State of Alaska  
Department of Fish and Game  
Sportfish Division

Nomination Form  
Fish Distribution Database

Nomination # <u>07-238</u>	ADF&G Fisheries Scientist	Date
Revision Year: <u>2006</u>		
Revision to: Atlas <input type="checkbox"/> Catalog <input type="checkbox"/>	ADNR OHMP Operations Mgr.	Date <u>10/29/07</u>
Both <input type="checkbox"/>	<i>[Signature]</i>	Date
Revision Code: <u>F-2</u>	FDD Project Biologist	Date
	Cartographer	Date

SUBJECT: Transmittal Letter for Nomination to Delete a Portion of Ship Creek from the Atlas and Catalog of Waters Important for Spawning, Rearing or Migration of Anadromous Fishes

# FORT RICHARDSON DAM

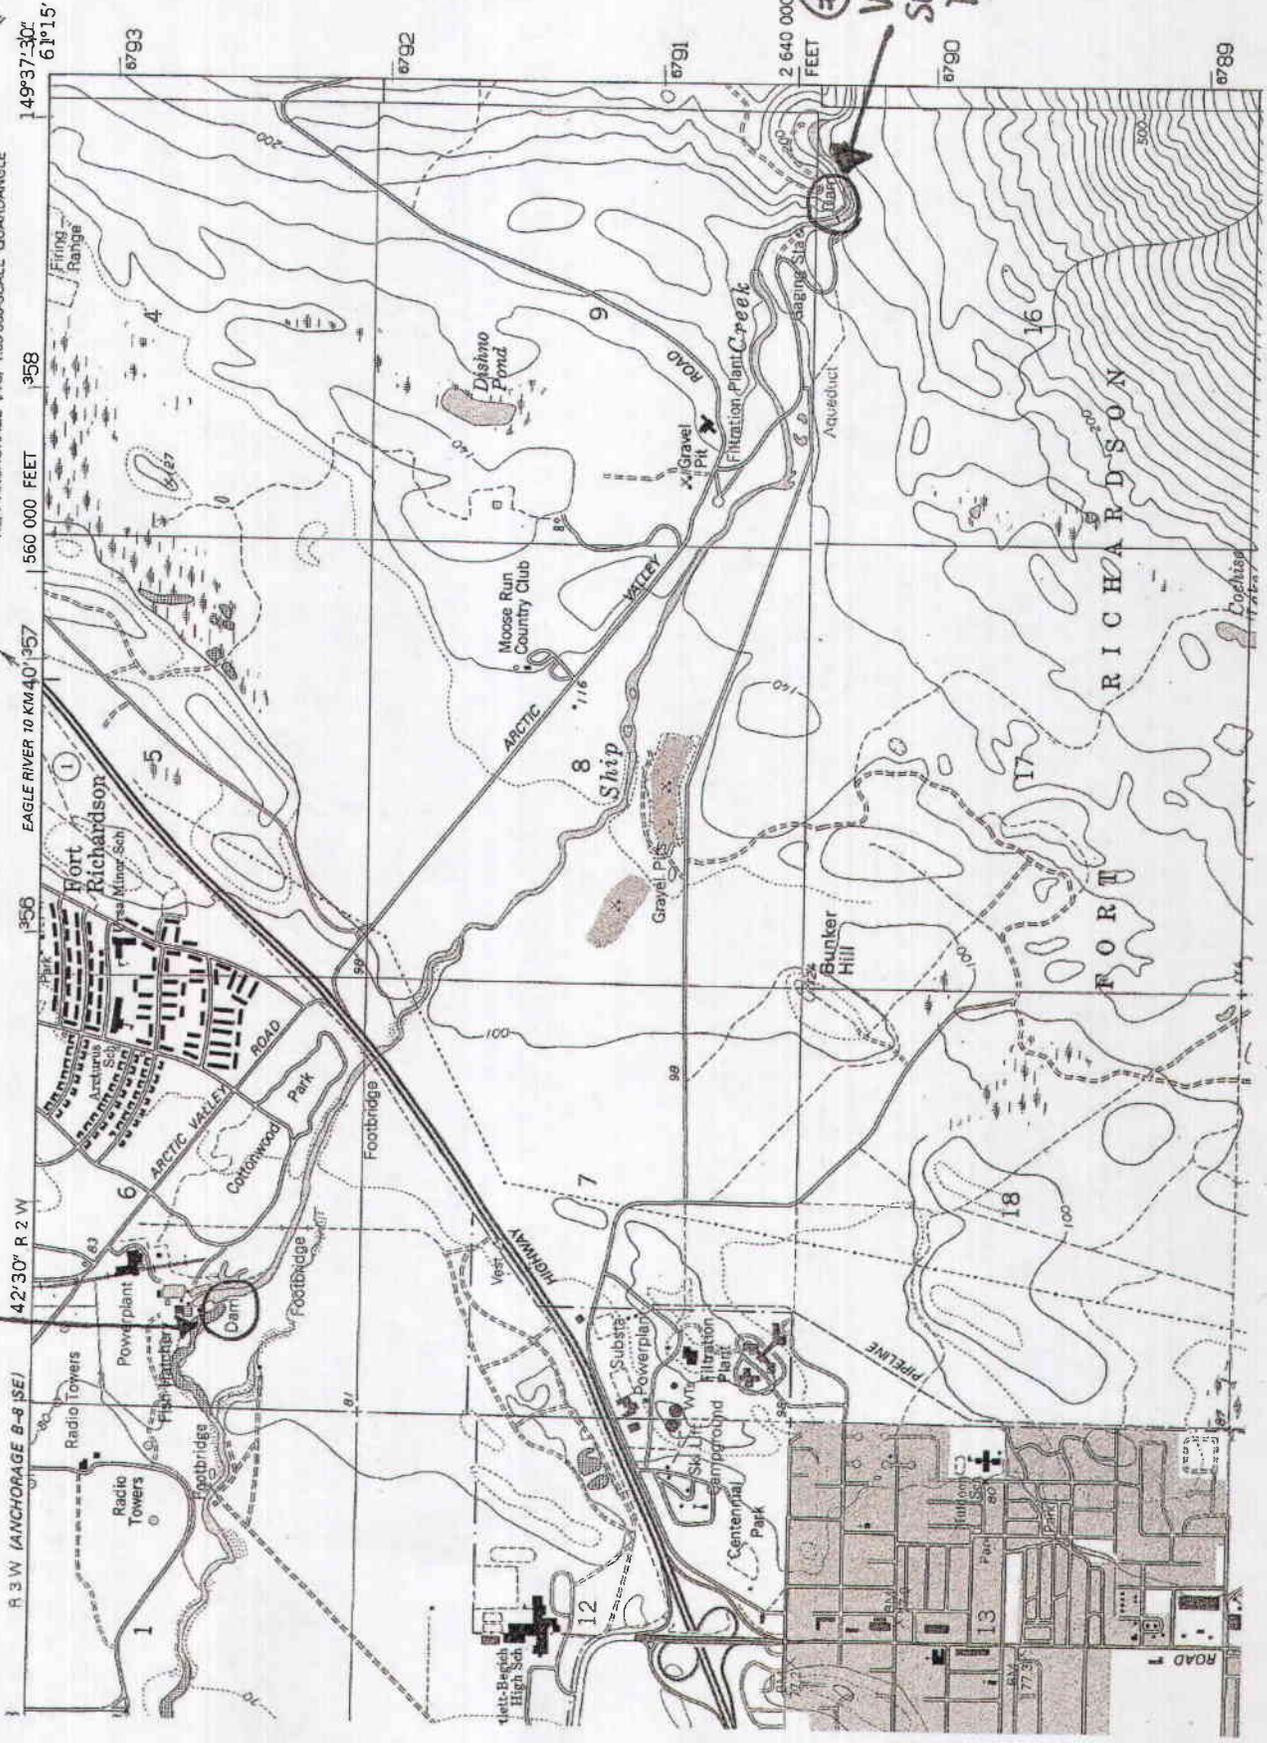
- A second dam upstream from the Elmendorf dam at the Fort Richardson hatchery is approximately 3,000 feet downstream from the Glenn Highway, and is a single concrete structure 80 feet wide and 5 feet high.

#1  
ELMENDORF  
DAM

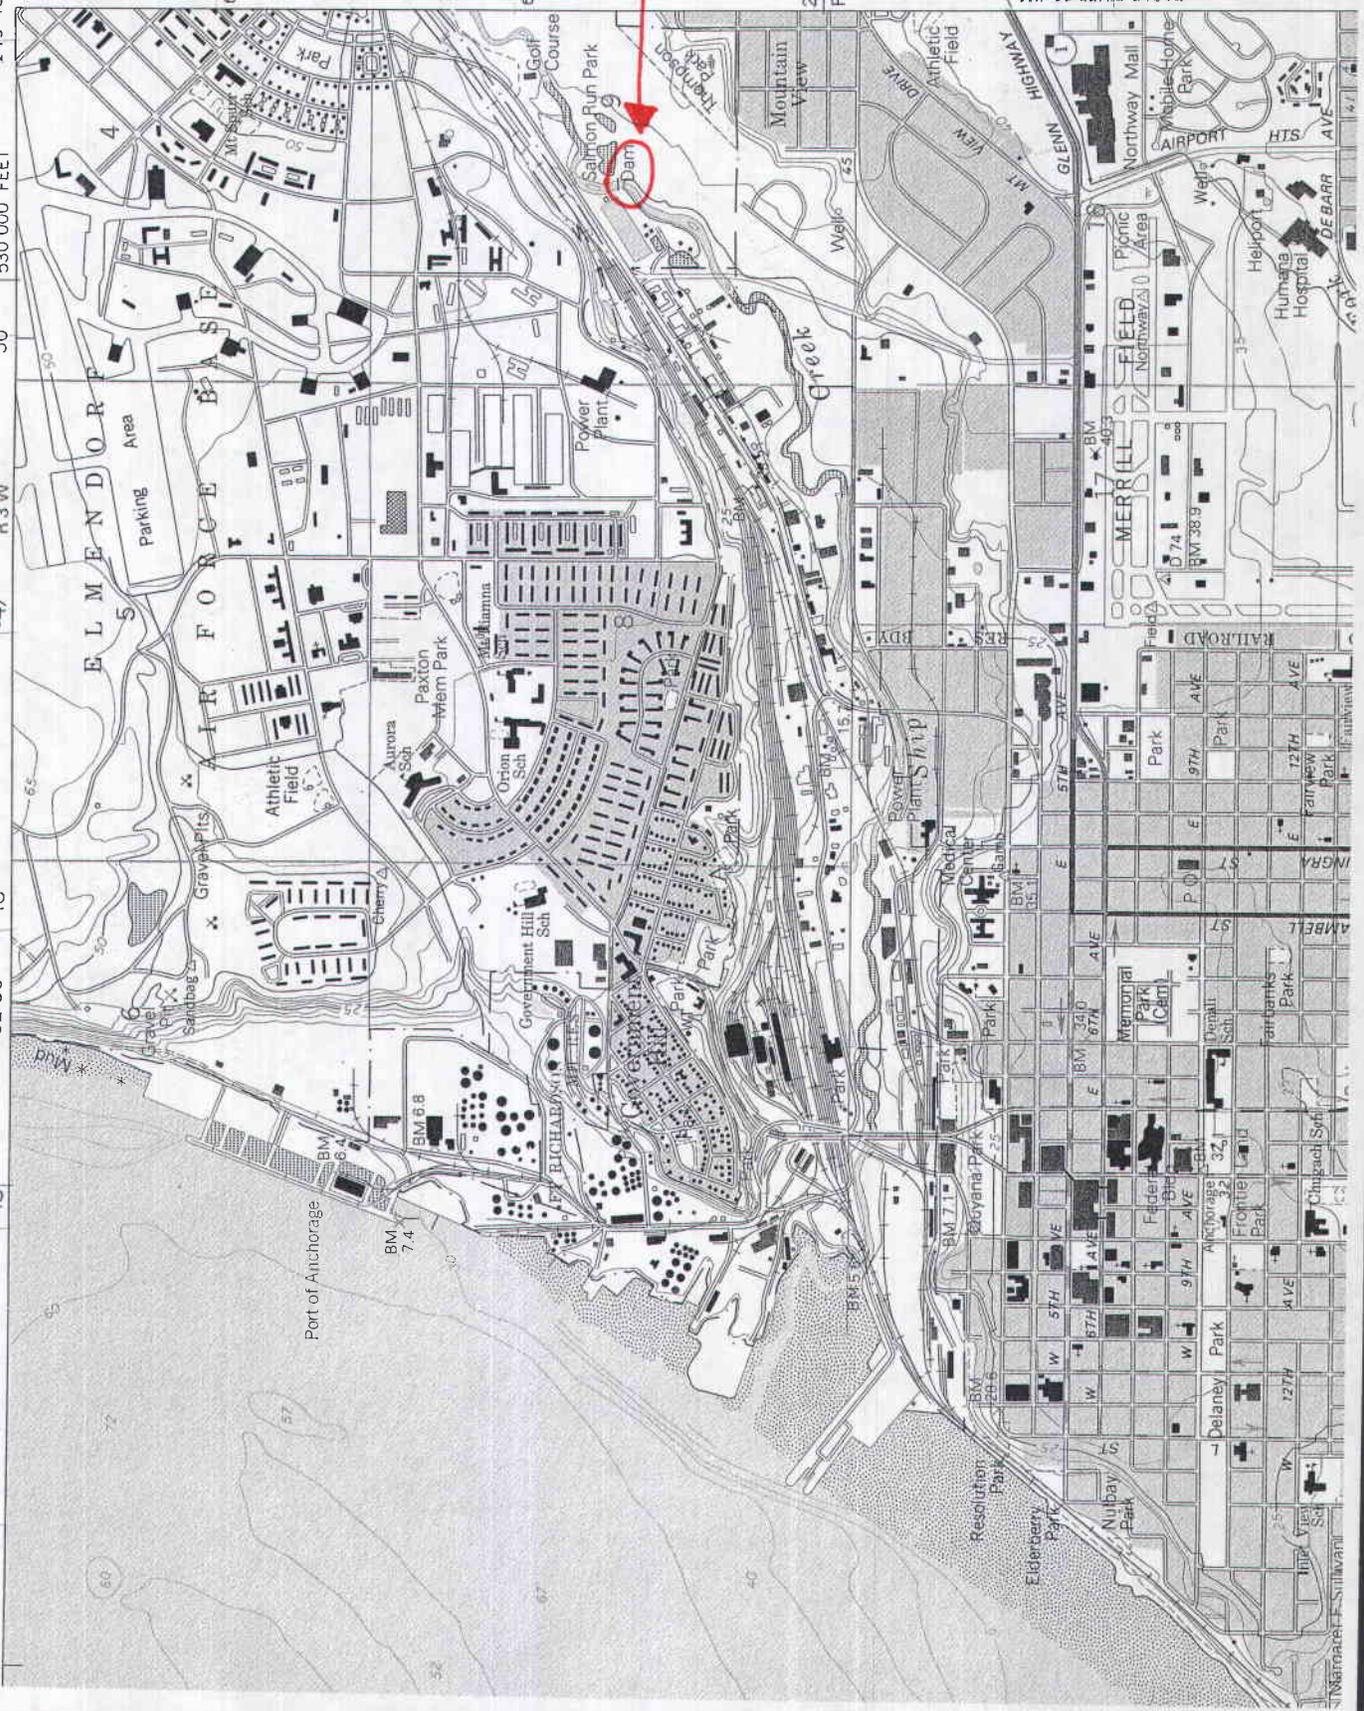
**Comments:** Request that the portion of Ship Creek above the Elmendorf dam be deleted from the Catalog of Waters Important for Spawning, Rearing or Migration of Anadromous Fishes and the Atlas to the Catalog of Waters Important for Spawning, Rearing or Migration of Anadromous Fishes. The Elmendorf dam, approximately 1,600 feet upstream from Reeve Boulevard, is comprised of two sheet pile dams approx 130 feet wide, with a total height of approx 12 feet, and is a complete barrier to upstream fish passage.

1. Elmendorf AFB requests that the portion of Ship Creek upstream of the Elmendorf dam be deleted from the Catalog of Waters Important for Spawning, Rearing or Migration of Anadromous Fishes and the Atlas to the Catalog of Waters Important for Spawning, Rearing or Migration of Anadromous Fishes. We request mutual support from the ADF&G for the Air Force mission with continued prohibition of fish passage upstream of the Elmendorf dam. Elmendorf AFB has substantial concerns with any proposal to remove or modify the Elmendorf dam, as noted in the Nomination Application and Exhibit 1 attached.

**Iliamna D-3** quadrangle

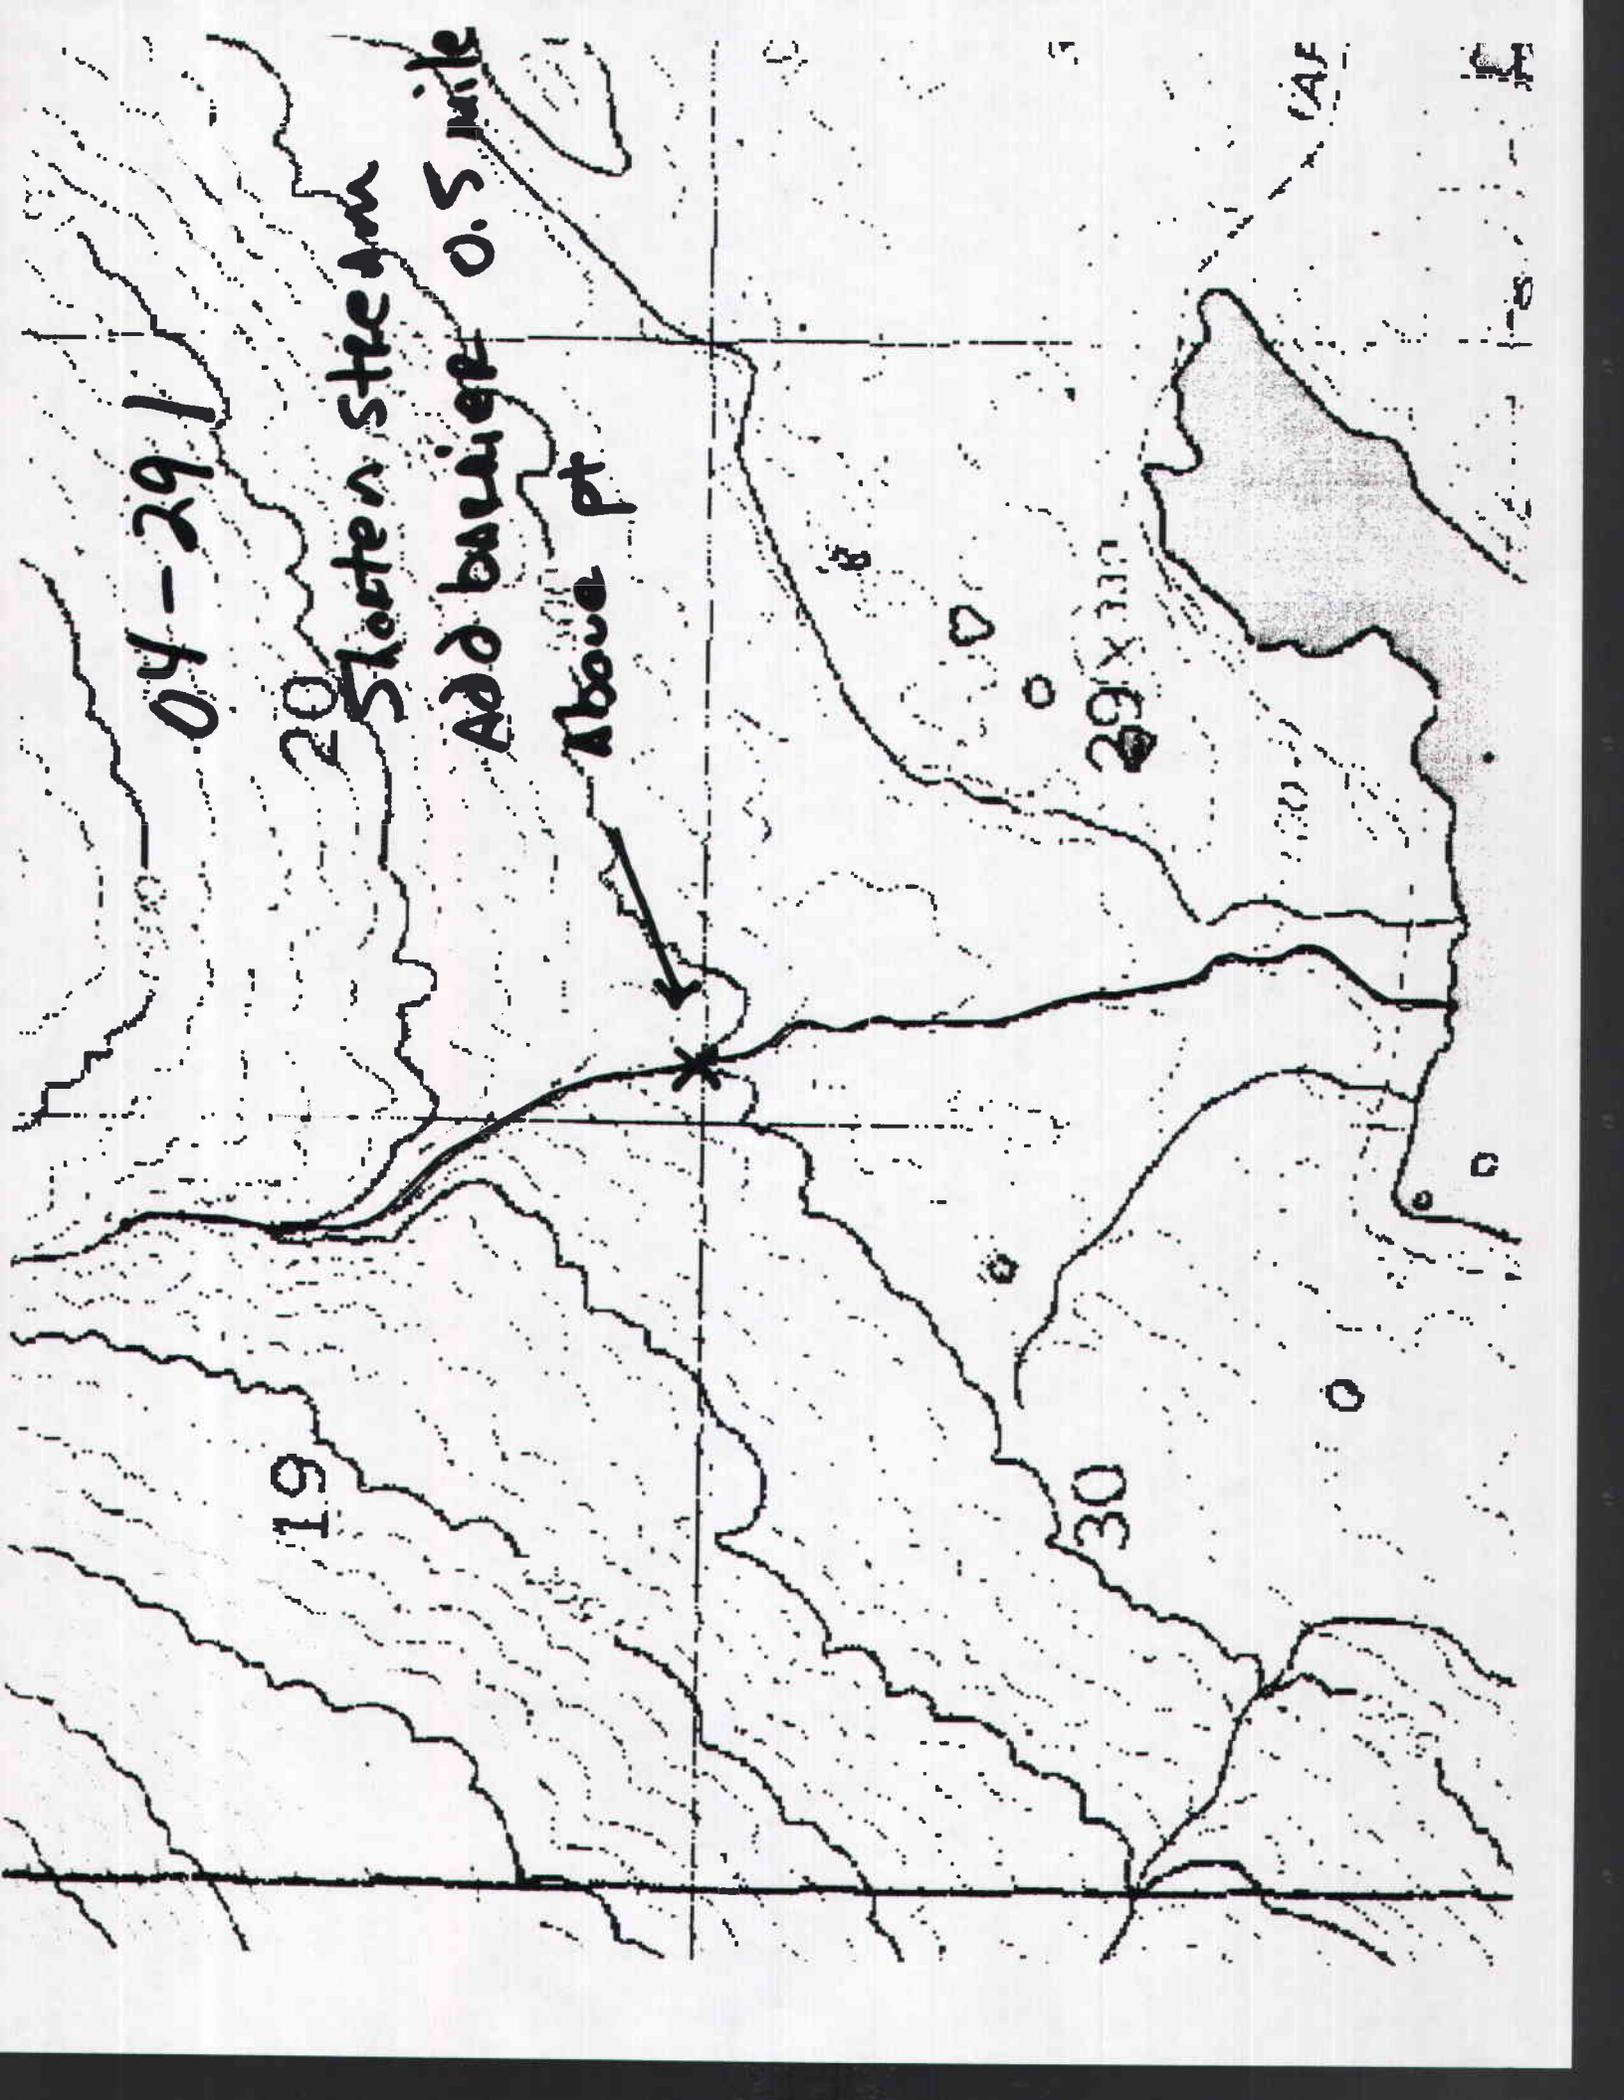
**Comments:** This stream is currently listed as Anadromous. Field studies indicate that the Anadromous reach ends approximately 0.5 miles upstream of the sampling location due to a 200' barrier waterfall. The stream is currently listed as Anadromous approximately .82 miles above the barrier falls. Nine (9) Dolly Varden were captured. Sampling location: N59.80264 W159.96252 (WGS84) \* Red marker on map corresponds to sampling location. Sampling method: Fish were captured using a backpack electroshocker. Area sampled: 0.6 miles downstream of intersection between stream and proposed alignment. Fish captured/observed: Dolly Varden: 128mm, 155mm, 37mm, 109mm, 127mm, 80mm, 109mm, 130mm, 151mm. Unspecified Pacific salmon were observed spawning approximately 500meters below sampling location. *sockeye*  
 Unnamed stream drains directly into Lonesome Bay. *Stream documented for 50*  
 E57.85 *Shoreline stream, add barrier 0.5 miles from sampling site*

Add barrier 0.5 mile
